## 2.0 RESPONSE TO COMMENTS

Letter 20      Max Alexander, City Resident

Photo #14

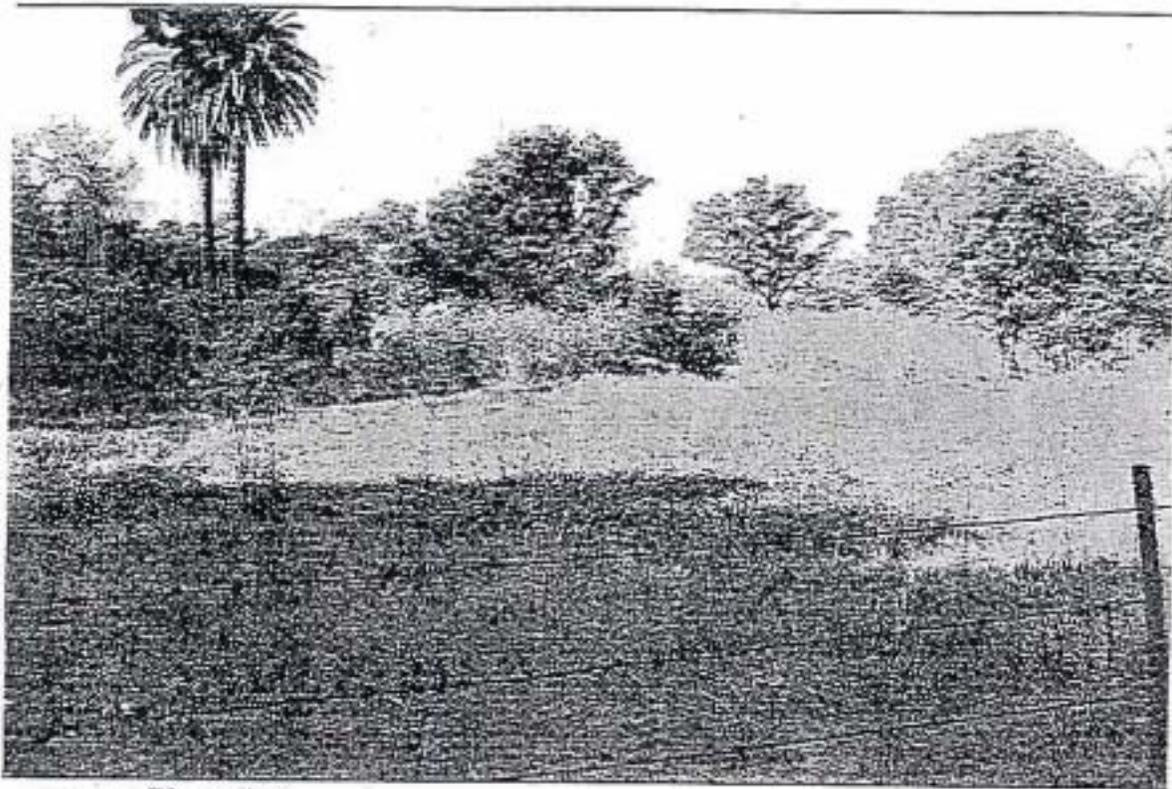
Lot C2 in Photo #14 is an undefined area behind Lot C1 that contains at least an acre of tree free area. The twin palms mark the entry into the old Van Maren ranch house.

Photo #15

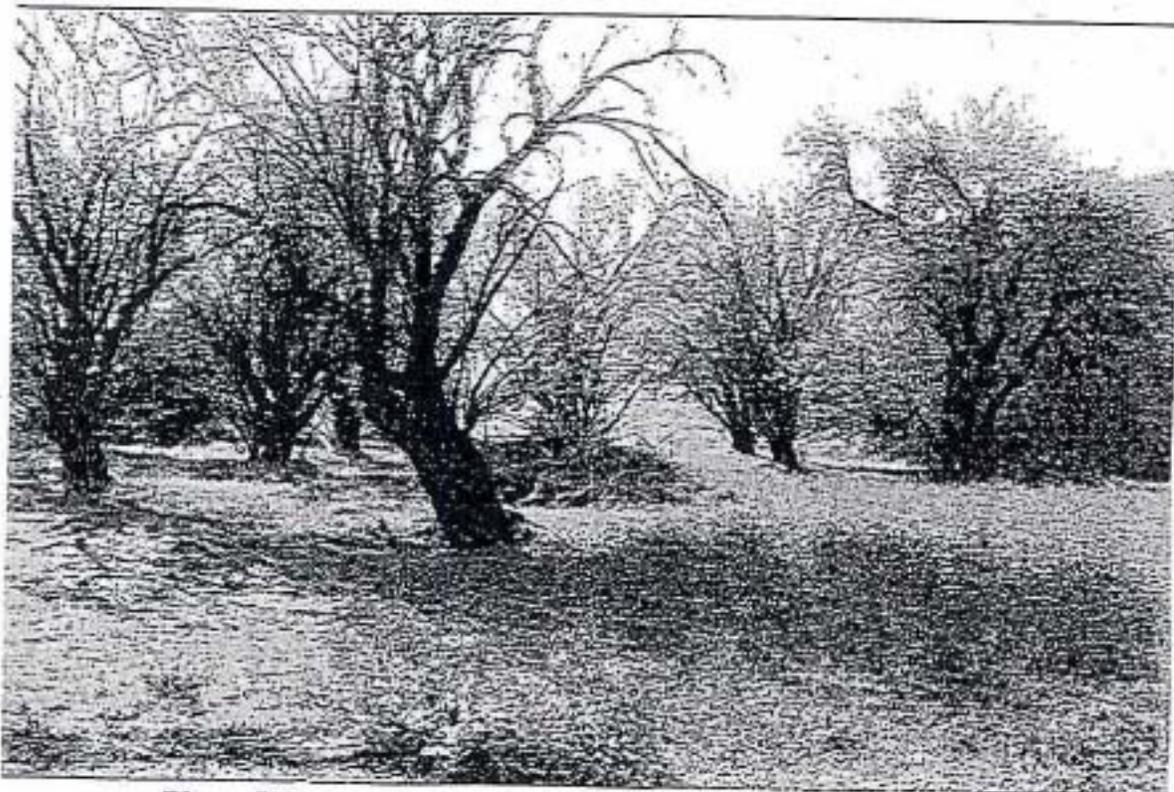
Lot D, shown in Photo #15, is an area of approximately 0.45 acres that is still a part of the old almond orchard.

Photo #16

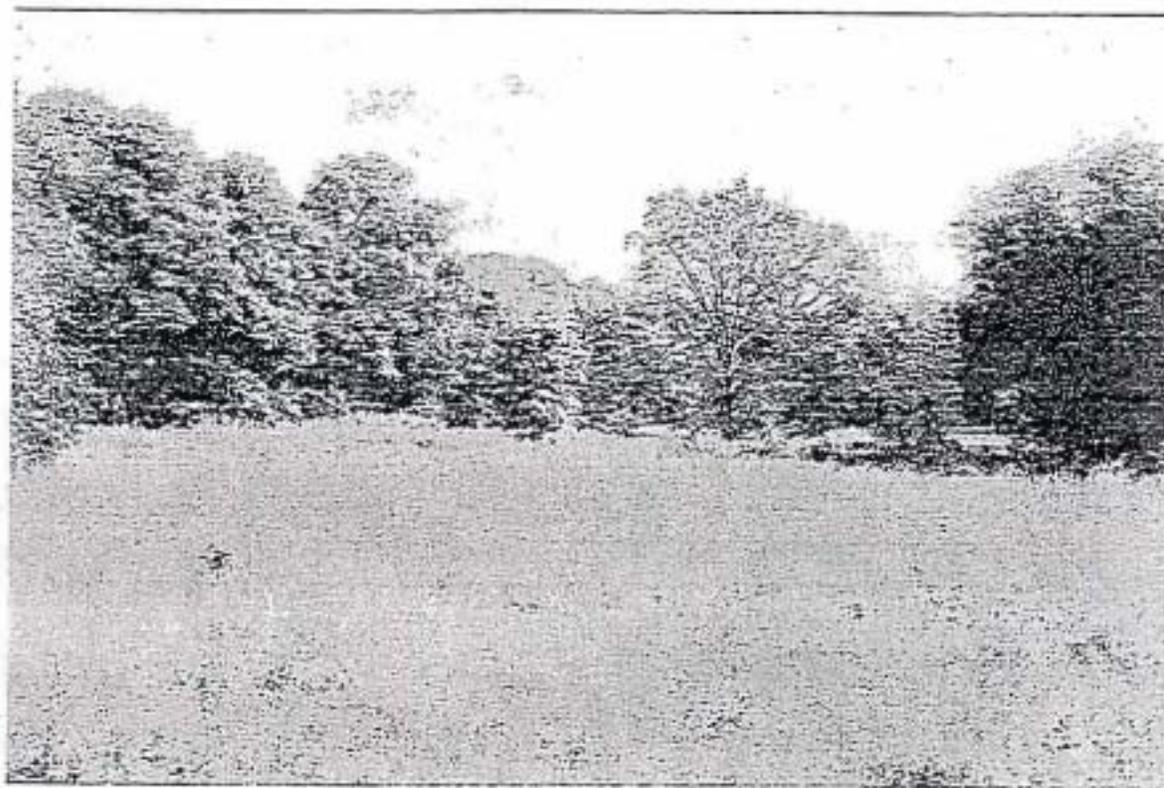
There is an additional plot of ground that lies north of Lots B and the Woodside Drive SPA. This plot, which is shown in Photo #16 is approximately 3 acres in size and was previously used to raise hay. Since cultivation has ceased, numerous trees have taken root in some areas. The large trees along the northern fence line are seen on the left side of the photo. Many of these trees are in the same condition as those shown in Photos #12 and 13.

If the purpose of the habitat review was to describe existing conditions, then I believe the amount of Oak Woodland was grossly over stated. If on the other hand the purpose was to identify areas of potential Oak Woodland, then the amount was grossly understated. Oak trees are like weeds; they will take over any area where they are not consistently removed. It is obvious from the pictures that oak trees get their start when birds and squirrels lose the acorns in the tall grass around the base of fence posts and existing trees.

The habitat mapping in the Biological Resources section should be considered accurate at a planning level, not to the level of accuracy of an arborist survey. Oak woodland habitat shown on the site is primarily characterized by moderately dense to sparse, savannah-like woodland with an annual grassland understory. This oak woodland supports valley oak (*Quercus lobata*), interior live oak, and blue oak (*Quercus douglasii*), but may also include remnant orchard trees and other tree species. Impact acreages identified in this document should be considered a "worst case" scenario and, as mandated by mitigation measure **MM 4.9.3a**, an arborist survey is required prior to any development that would inventory and map all oak trees within the development area and would also indicate the health of all trees mapped. Mitigation for non-native trees within oak woodland habitats is not required as part of this EIR.

This issue has been previously addressed. Refer to Response to Comment 20-5. Mapping for purposes of the EIR is conducted at a planning level and areas designated as oak woodland may include non-native trees, such as almonds, moderately large areas of annual grassland, and trees that are not healthy.

Photo  
#17

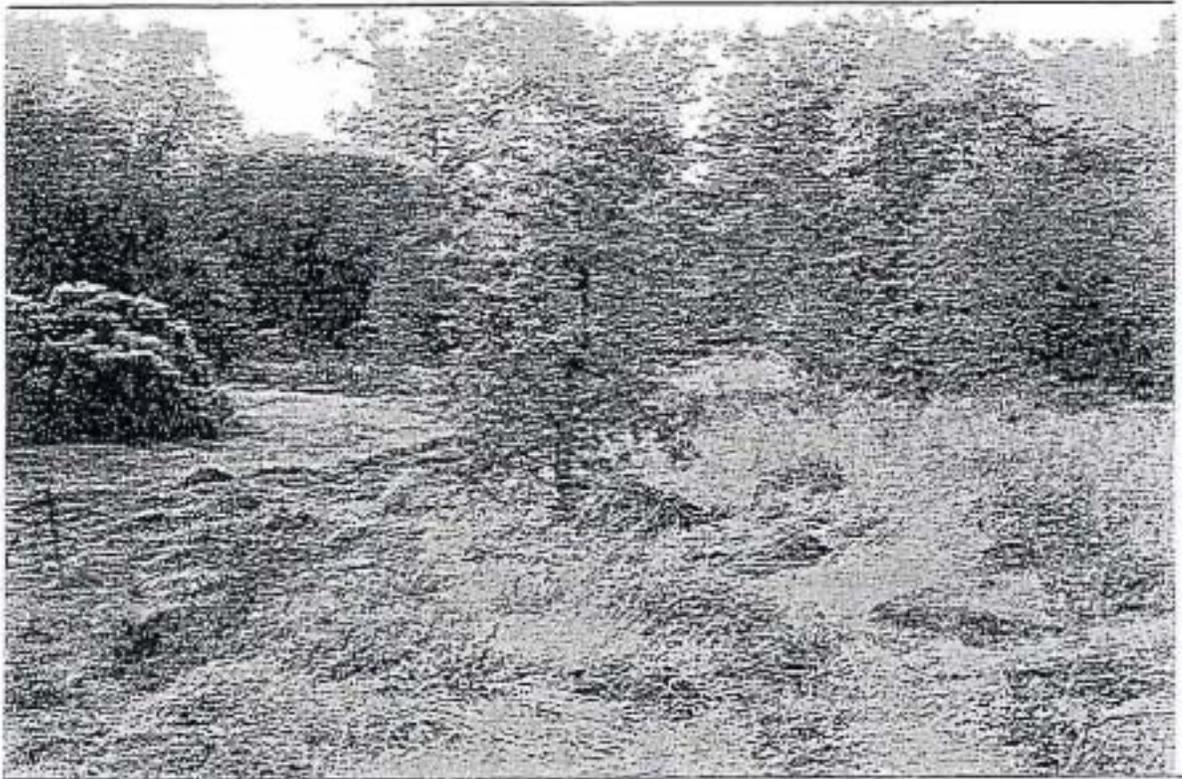
I fail to understand why it is necessary to take an additional 4.5 acres for a park. There are several suitable park sites within the boundaries already being taken for open space and recreational areas. The area between the Beazer homes and the creek should be more than adequate. This area, which is shown in Photo #17, was the location for the Van Maren horse barn, hay barn, and corrals. If that is insufficient, there are several acres of open space and recreational areas on the north side of the creek. This area shown in Photo #18 is larger than the park currently proposed.

Comment noted.
